Solicitation Information
RFQ #7464392

Title: Rhode Island Lottery Parking Improvements
Closing Date and Time: May 28, 2013 at 11:00 am Local Prevailing Time

ADDENDUM # 2

C3

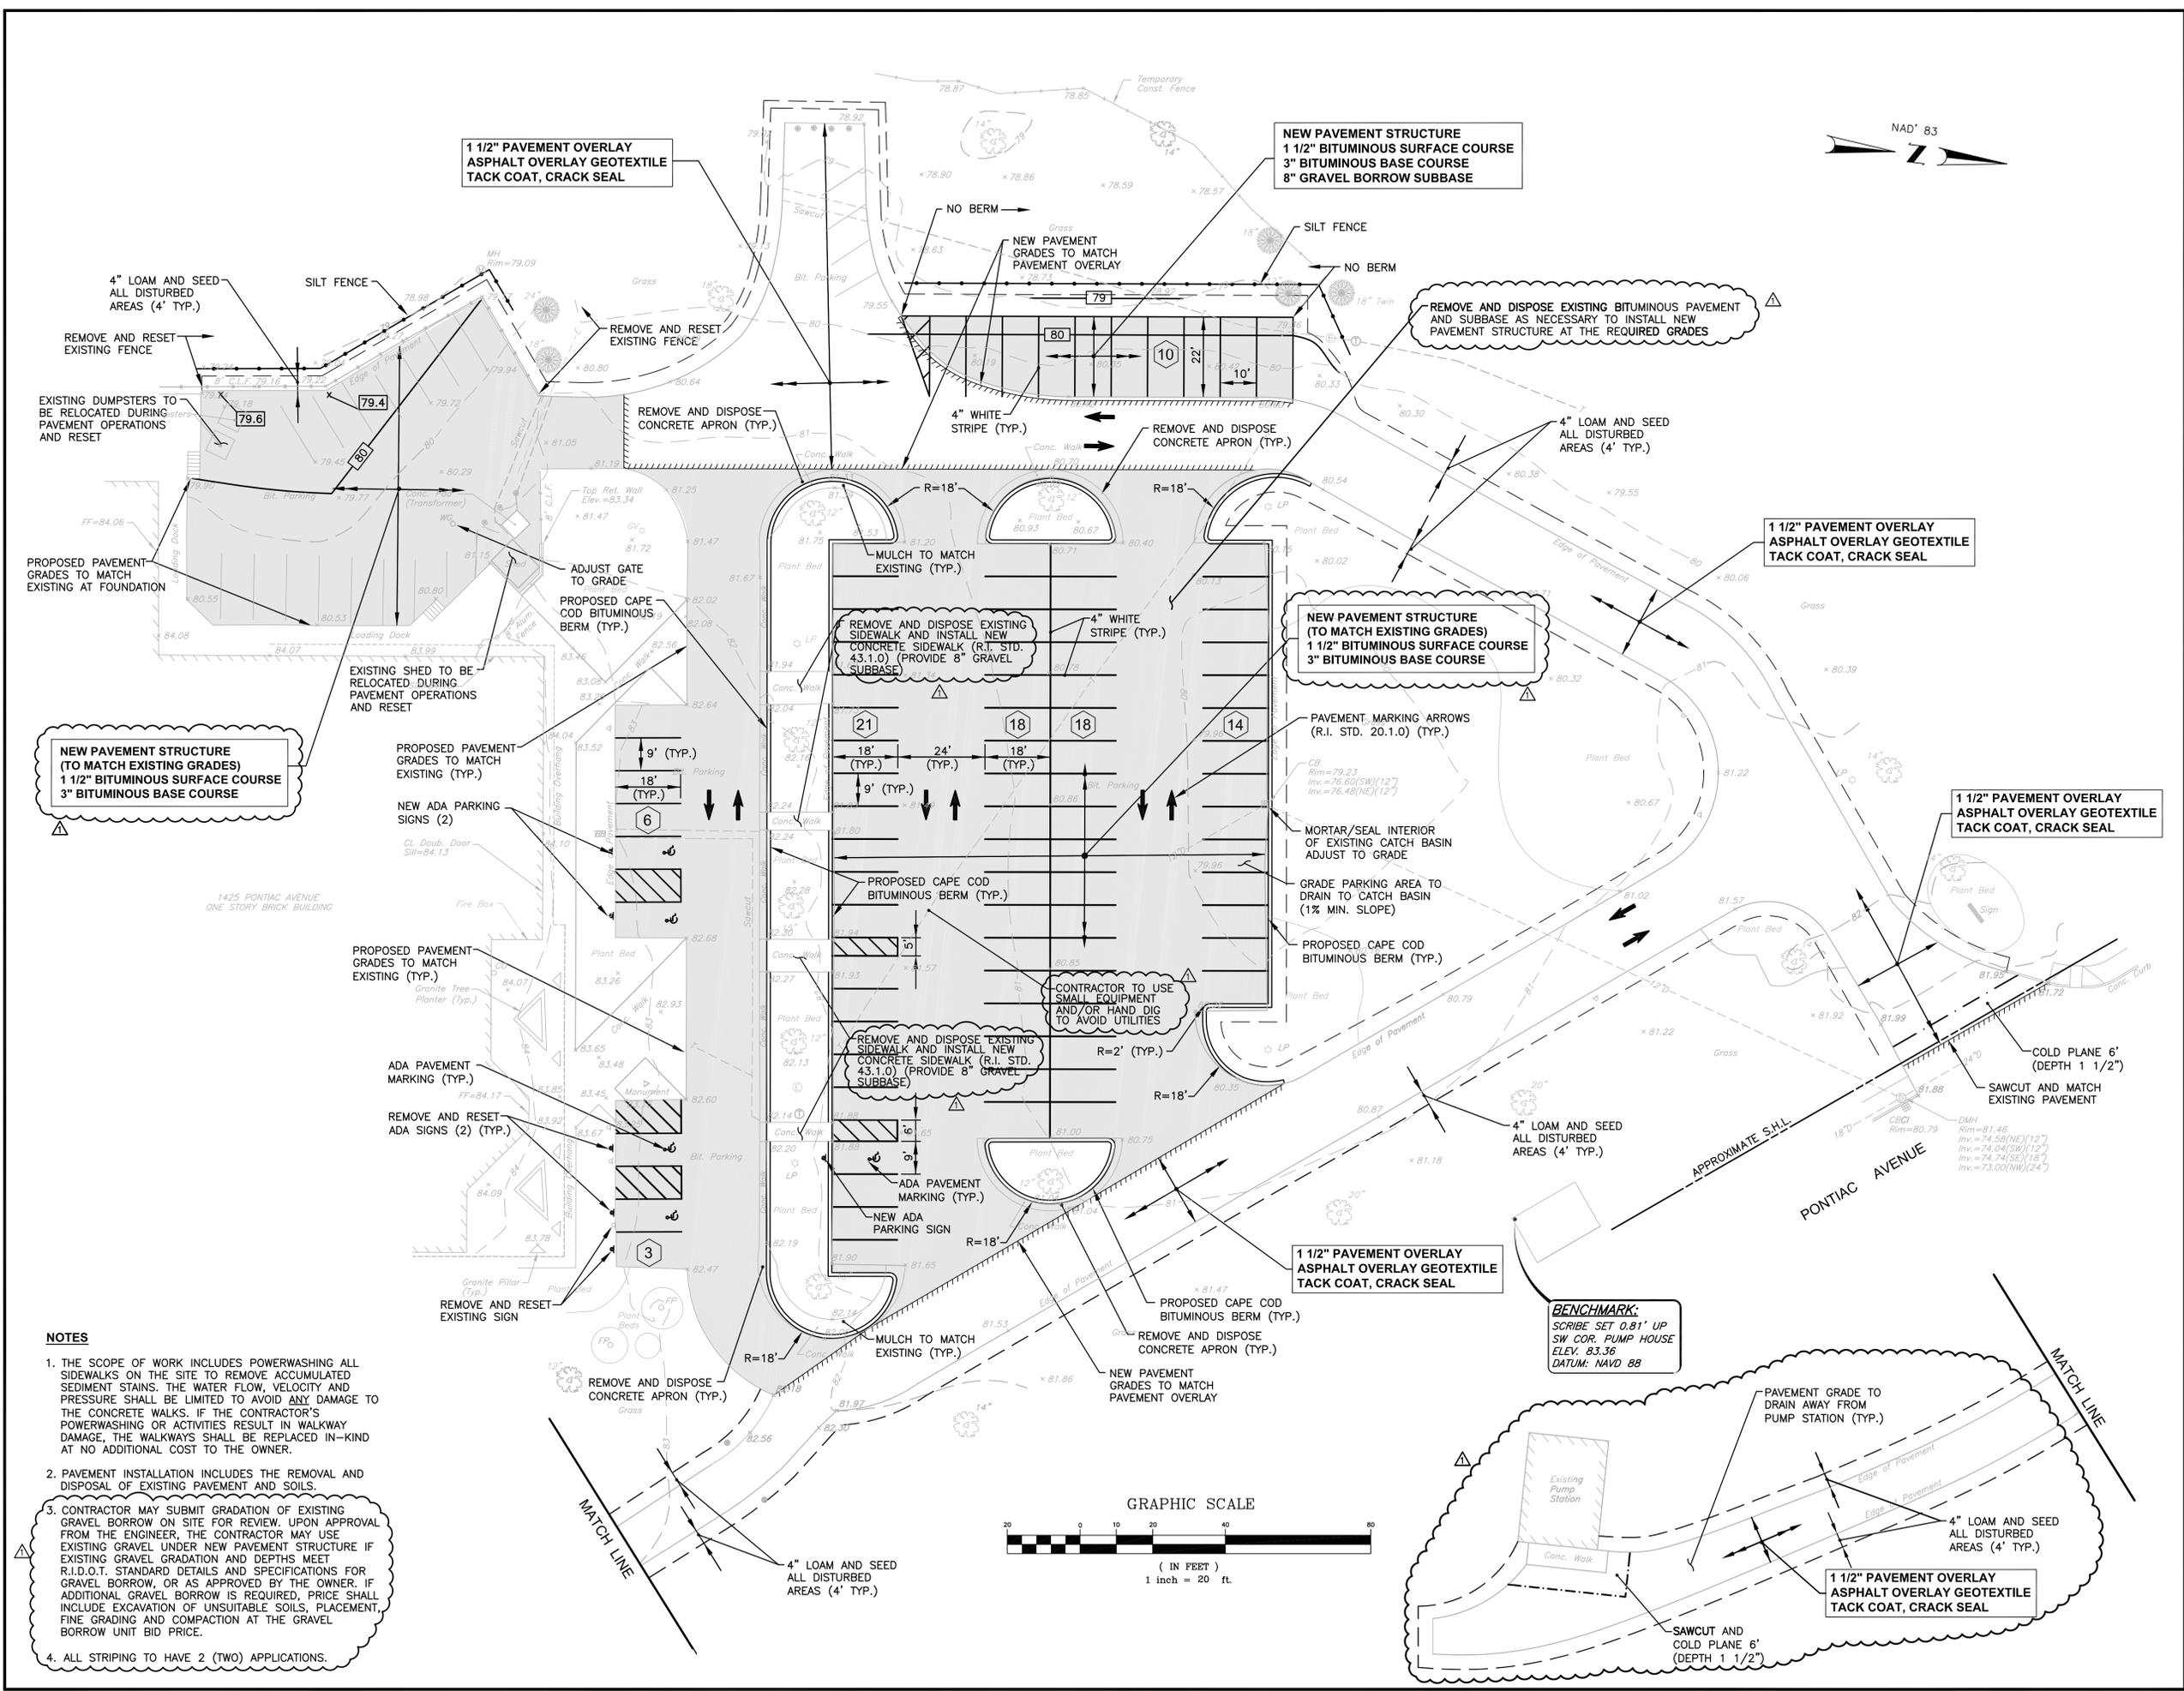
Question 4 - In the areas shaded on the drawings, you call for supplying new gravel. 1. In areas that show full depth excavation, can reclaiming be done as an alternate?

Question 9 - In the shaded areas on the plans: We're working at night. What happens on day two when they show up and there's not parking lot there?

A - The pavement structure for the shaded existing parking area has been revised see attached plan.

A - All building occupants will be notified that the parking lot will not be completed in one night and they will have to park and drive on gravel/dirt surfaces for a duration. The contractor will be responsible for leaving the parking areas and driveway in a manner that will allow vehicles to utilize the parking area daily, and maintain ADA accessibility into the building.

DRAWING NUMBER
C4
SHEET: 5 OF 5
CONSTRUCTION PLANS

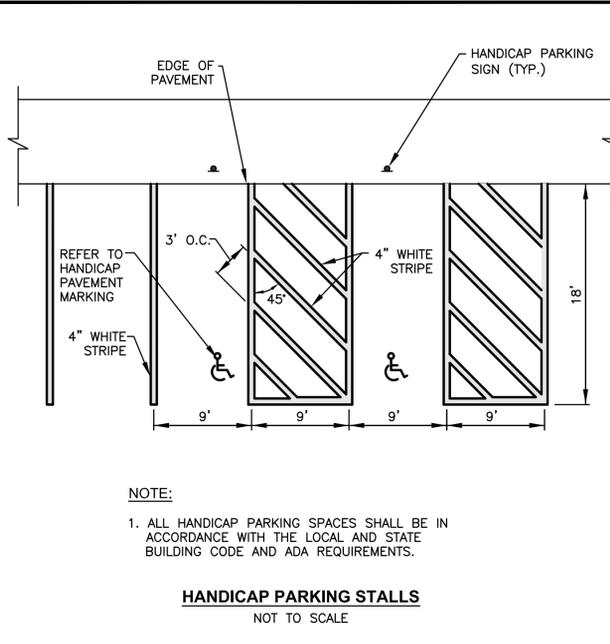
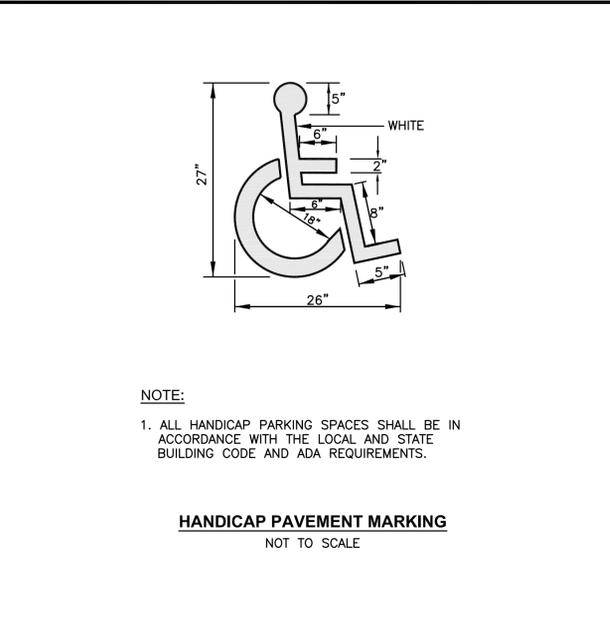
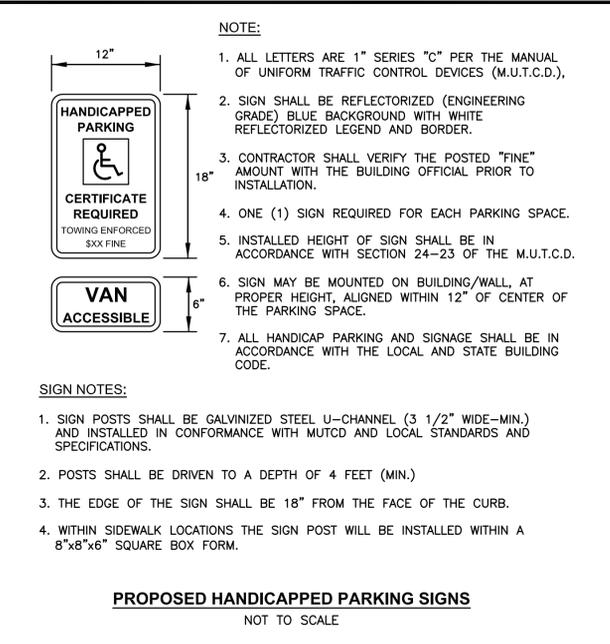
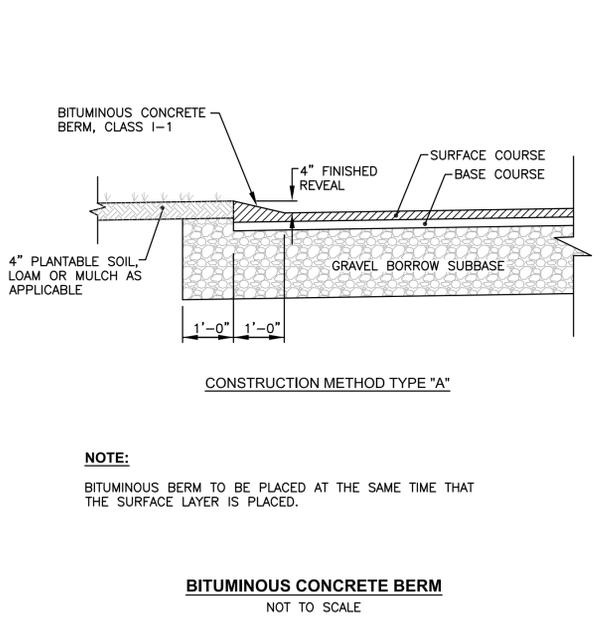
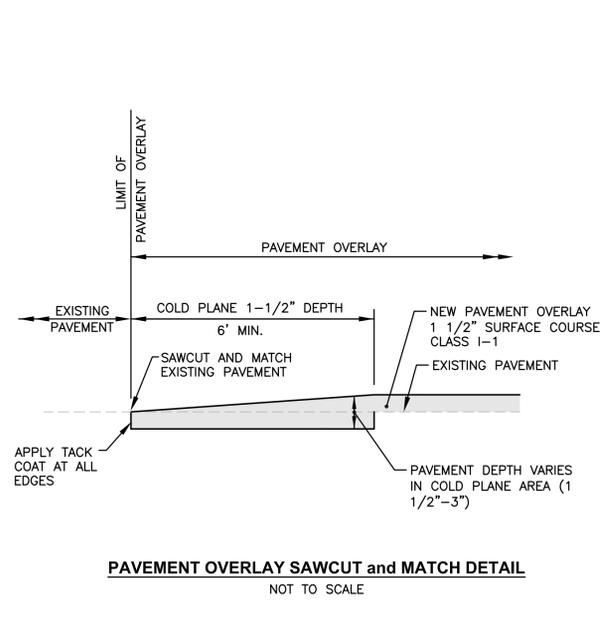
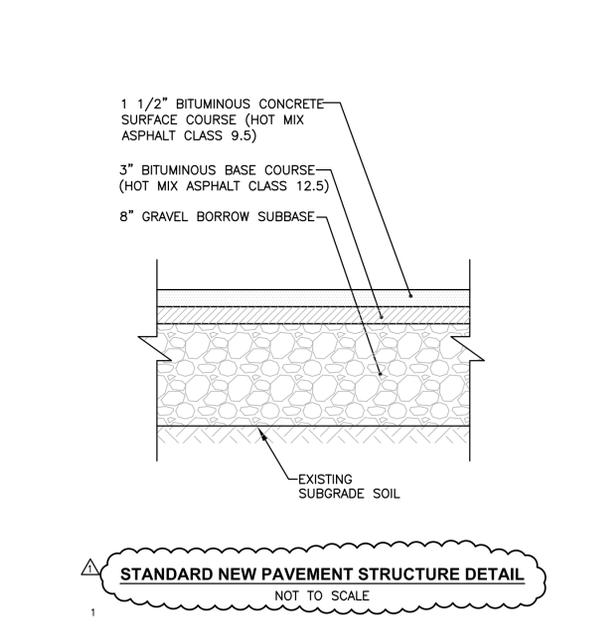
Question 2 - On the pavement section the base course for this job call for a 12.5 millimeter asphalt mix for the base course, but that is not consistent with the state standard of 19 millimeters. Can 19 mm superpave be substituted for 12.5 mm base course?

A - The proposed pavement structure as referenced on the plans will be the pavement used for this project, no substitutions will be accepted. Supplemental Specifications for Hot Mix Asphalt 9.5 and 12.5 are included in this addendum.
